Value Engineering Change Proposal Of Irrigation and Drainage Networks in Ramhormoz - Iran

\$ 100 m Saving of modifying Design flood in a Dredging Project of Karun River

Change in lateral alignment according to the natural slope

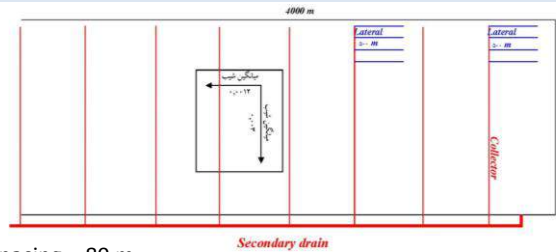
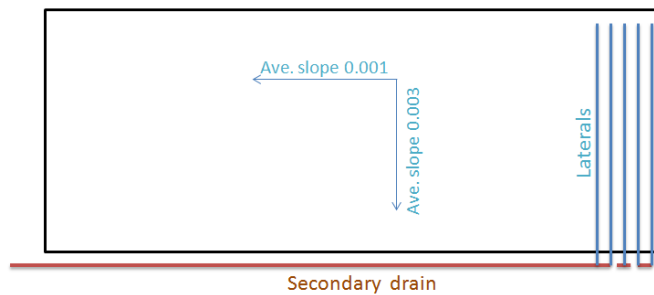
Layout of subsurface drains (Base Case)

Lateral spacing = 80 m

Lateral length = 500 m

Pipe collector spacing = 80 m

Number of collectors = 8

Lateral diameter = 100 and 125 mm

Collector diameter = 160 and 300 mm

Layout of subsurface drains (Proposed Case)

Lateral spacing = 100 m

Lateral length = 1000 m

Pipe collector : no needed

Lateral diameter = 100 and 125 mm

- Use of the natural slope
- Constant drain depth along the lateral
- Lower sedimentation because of steeper slope
- No need for any type of collectors
- Lesser land loss

- **Cost Saving of 23 billion Rials (about 0.9 million USD)**
- **No need for any type of collector drains;**
- **Constant depth of the laterals;**
- **Lower sedimentation risk in the drains because of higher water velocity; and**
- **Easier maintenance.**
